Access Compliance Report

Public Rights-of-Way

(Curb Ramps)

Intersection ID: 10037035	Main Street: S_TRYON_ST	Cross Street: N/A	Location:	N
ADA ID: FB76C27840D3	Ramp Type: Perp	Initial Pass/Fail: Pass	Overall Compliance: No	Severity Score: 0
Codes/Mitigation Info/Possible Solution		Field Measurements/Component Compliance

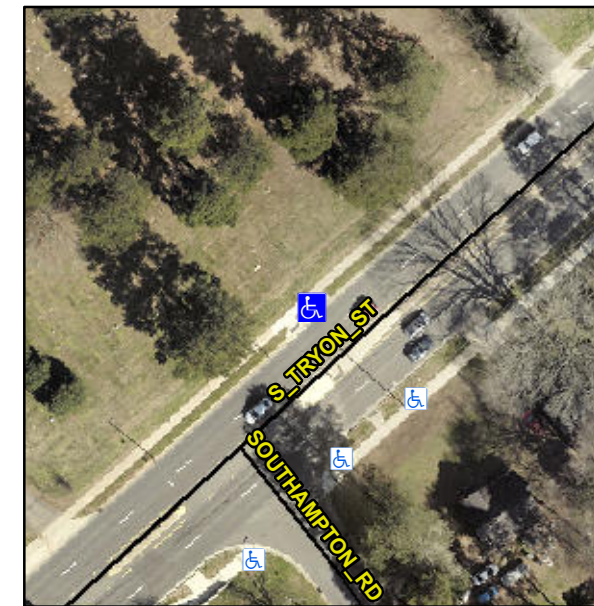
Remove & Replace Detectable Warning System.

R305.2
